CITY OF SACRAMENTO PLANNING COMMISSION
1231 "I" STREET, SUITE 200, SACRAMENTO, CA 95814

- A. Negative Declaration.
- B. Special Permit to construct a 7,200 square foot medical office building on 6.0+ partially developed acres in the Hospital (Methodist Hospital Planned Unit Development) (H{PUD}) zone.
- C. Methodist Hospital Planned Unit Development Schematic Plan Amendment to allow construction of a 7,200 square foot medical office building.

LOCATION: 8001 Bruceville Road

APPLC. NO. P91-015

SITE PLAN
1" = 60'

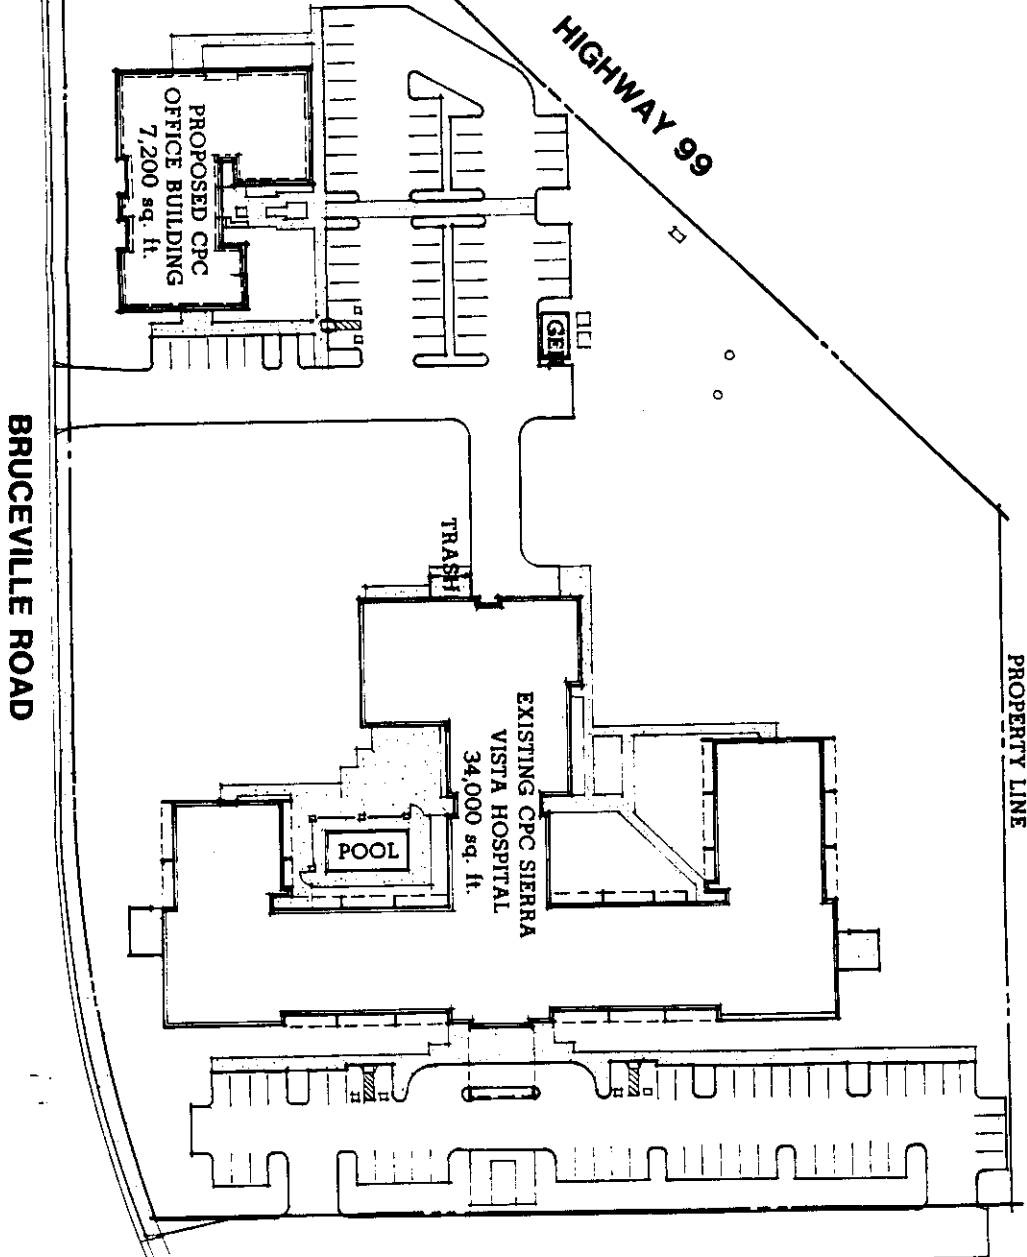
The submitted site plan indicates the office building to be located in the northern corner (where Bruceville Road abuts the Highway onramp) of the parcel. The proposed structure is located 25 feet from Bruceville Road and approximately 70 feet from Highway 99. The site plan meets all the requirements of the PUD Development Guidelines. A schematic landscape plan has been provided, however, staff suggests a detailed landscape plan be provided for review and approval of the Planning Director prior to the issuance of Building Permits.

The proposed medical office building is located on the same parcel as the existing hospital. Therefore, parking must be provided on the parcel for both uses. The hospital requires 52 spaces and the medical office building, 36 spaces. Parking is provided for 108 cars which exceeds the 88 spaces required. The parking stalls meet the minimum required size and maneuvering area. A pedestrian walkway has been incorporated into the parking area. The Zoning Ordinance requires bicycle parking for a medical office building to be provided at ratio of one bicycle parking facility for every thirty parking spaces required. The proposed building requires one bicycle parking facility. The submitted plans do not indicate any bicycle parking provided. The applicant shall submit plans showing the location and type of bicycle parking facility for review and approval of the Planning Director prior to the issuance of Building Permits.

The submitted site plan indicates no new trash enclosure to be provided for the medical office building. The hospital has an enclosure on the north side, closest to the proposed medical office building. If a new trash dumpster is provided, a trash enclosure must be provided which meets the requirements of the Zoning Ordinance.

A PUD Schematic Plan Amendment is necessary due to the physical characteristics of the building. The schematic plan indicates medical office uses, however, the submitted site plan is a slight modification to the schematic plan. Staff recommends approval of the amendment.
